TECHNICAL BULLETIN

212-17-216

SUBJECT: HYDRAULIC SYSTEM #1 AND #2 ACCUMULATOR

P/N 212-076-007-003, REMOVAL OF

Figure 1Hydraulic System I Pre TB 212-17-216 Configuration

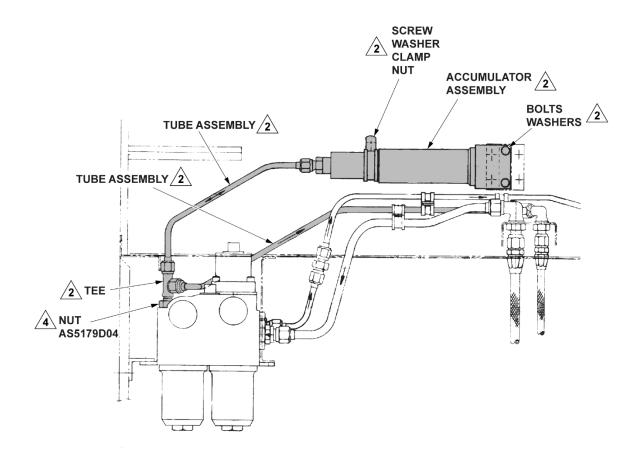
- 1. Prepare helicopter for maintenance.
- 2. Gain access to both hydraulic accumulators (BHT-212-MM-1).
- 3. Remove all parts shown in grey on Figure 1, 2 or 3 as applicable (BHT-212-MM-4).

Retain parts for relocation.

Parts no longer required.

Figure 2
Hydraulic System II Pre TB 212-17-216 Configuration S/N 30504 through 30755

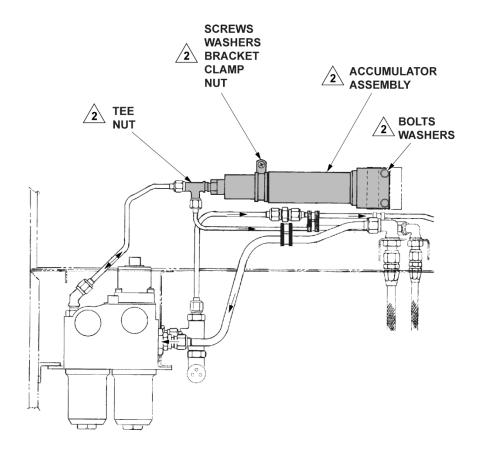
Parts no longer required.

Retain for re-use.

Hydraulic System II Pre-TB 212-17-216 Configuration 30756 through 31311, 32101 through 32142 and 35001 through 35103

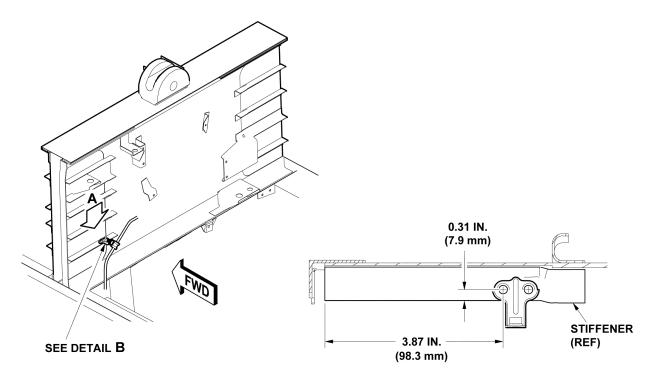
2 Parts no longer required.

Figure 4
Modification

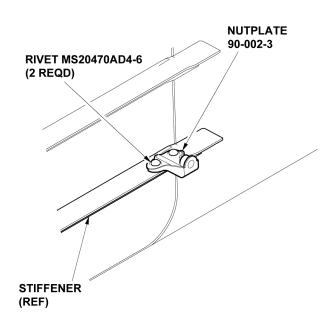
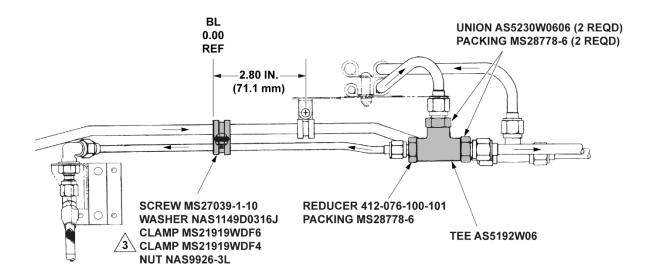
- 4. Install Nut plate 90-002-3 shown on Figure 4 as follow:
 - a. Install clamp MS21919WDG4, screw MS27039-1-10, washer NAS1149DO316J with spacer NAS43DD3-12N and nutplate on tube assembly P/N 212-076-571-001.Do not tighten screw at this time to allow proper positioning of nutplate.

- b. To prevent tube and stiffener preload, temporary install tube to fit and locate the nutplate on stiffener P/N 205-030-845-376 (Detail B) mark position of the nutplate and remove tube assembly.

- c. Install the nutplate 90-002-3 using rivets MS20470AD4-6 (of the proper length), to the lower left hand stiffener P/N 205-030-845-376.
 - d. Touch up the area as required with primer C-204 (BHT-ALL-SPM).

Figure 5 Hydraulic System I Post TB 212-17-216 Configuration

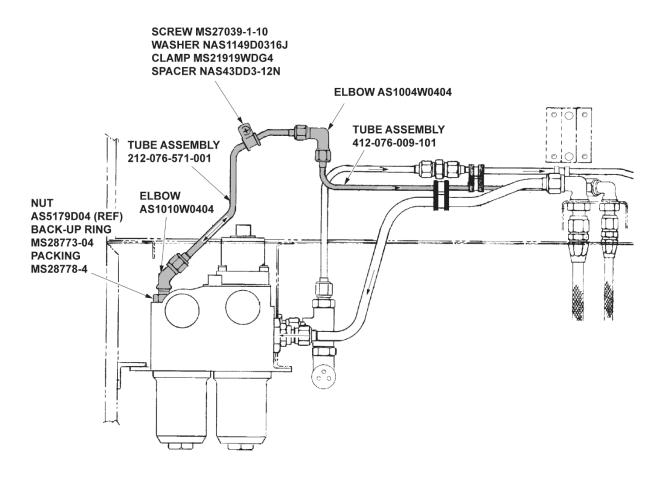
- 5. For helicopters S/N 30504 to 31311, 32101 to 32142 35001 to 35103, install hardware shown on Figure 5.
- 6. For helicopters S/N 30504 to 30755 install hardware shown on Figure 6.

Relocate clamps and hardware 2.80 inches (71.1 mm) away from center of bracket.
